Subject: **WATER AND WASTEWATER CAPACITY AVAILABILITY LETTER**  
**Beach Boy Plaza, DRC Case No. R18011**  
**401 South Fort Lauderdale Beach Boulevard, Fort Lauderdale**

City of Fort Lauderdale  
Public Works Department  
Water and Wastewater Capacity Analysis

**Beach Boy Plaza, DRC Case No. R18011**  
**401 South Fort Lauderdale Beach Boulevard, Fort Lauderdale**

Figure 1 – City Water Atlas

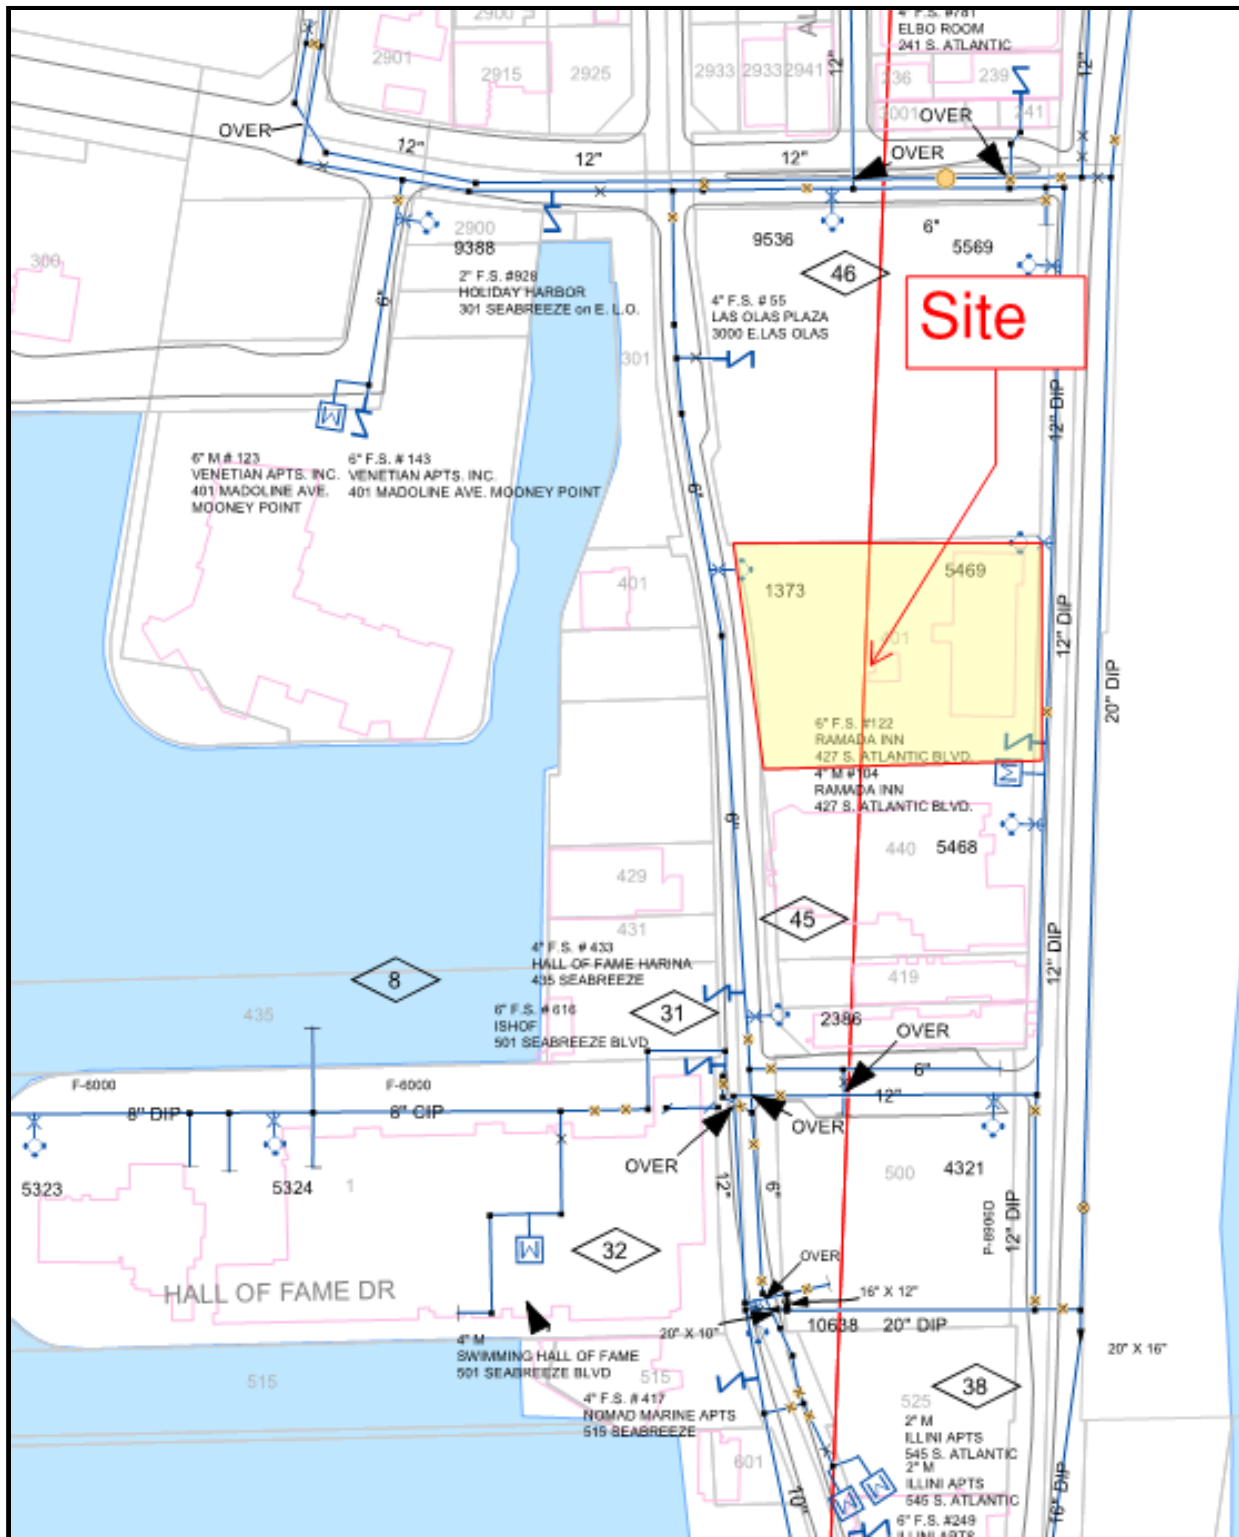
**Water:** The site is currently served by a 6-inch water main located along Seabreeze Boulevard which connects to a 12-inch water main along Las Olas Boulevard. See Figure 1.

**Evaluation of impact on existing distribution pipe (flow & capacity):** According to the site plan the applicant is proposing to utilize the 6-inch water main on Seabreeze Boulevard. The InfoWater hydraulic model was analyzed to determine the impact of this project on the existing 6-inch water. The existing water main has capacity to serve the project.

**Recommended Water Infrastructure Improvements:** No improvements required.
